City Center Connector

Meeting Summary

November 5, 2015

Concept Design

Figure 4: Proposed Stewart St. Station

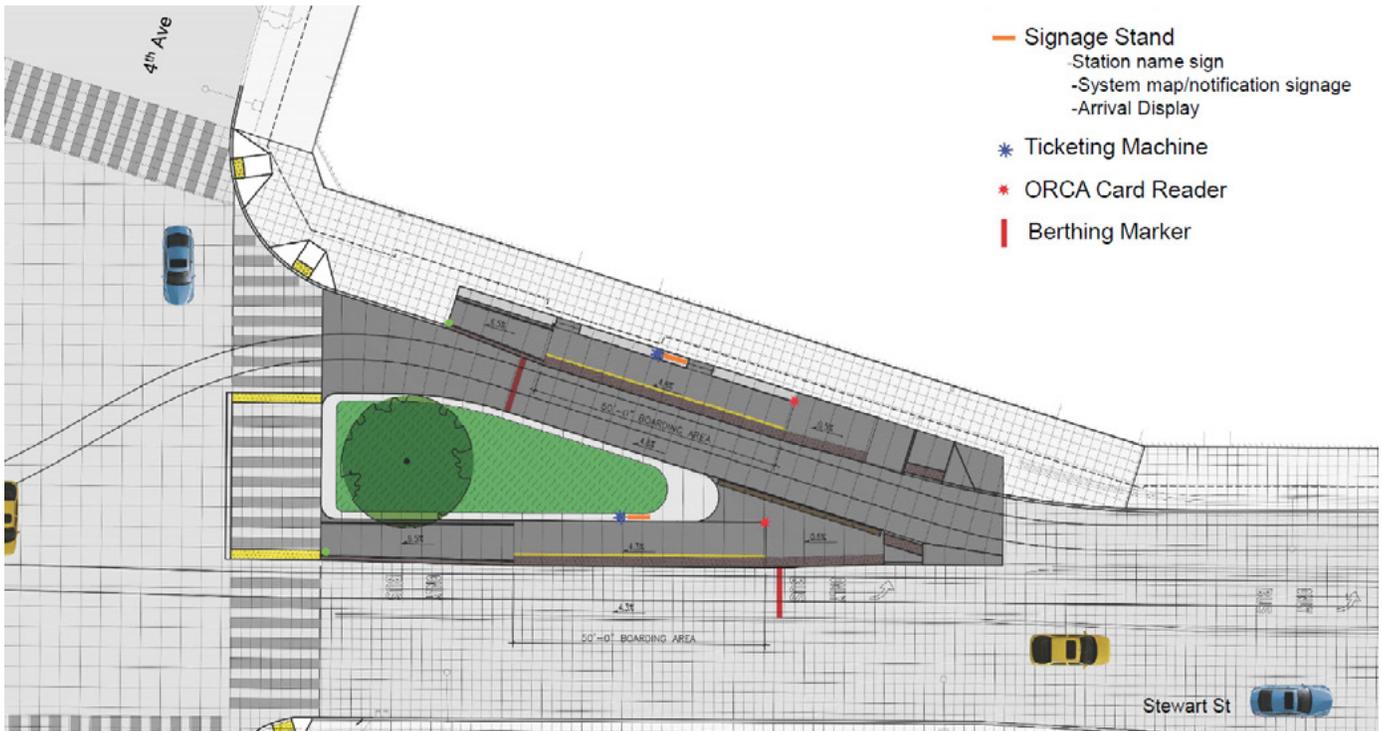
6. Demonstrate how the proposed stone materials are sustainably sourced.
7. Continue to explore potential locations for incorporating shelters at stops, including locations such as Jackson and Stewart Street stops where weather conditions can necessitate the need for shelters. Consider very light, minimal solutions to provide shelter.

Figure 5: Proposed Pike-Pine St. Station

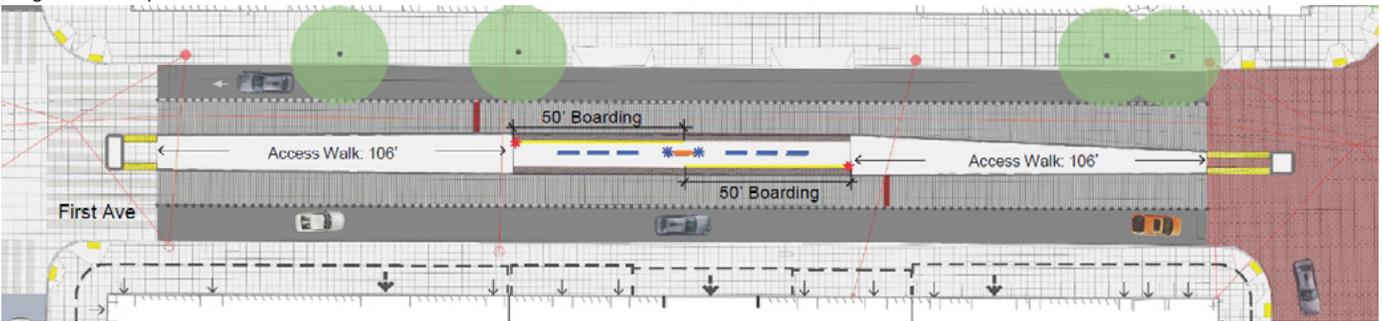
Commissioners thought the project team was successful in its approach to minimize the appearance of the street car station and tracks within the surrounding urban setting. The SDC encouraged the project team to research how much traffic will be generated from the Pike/Pine Station, which appears to be in isolation compared to the other proposed stations.
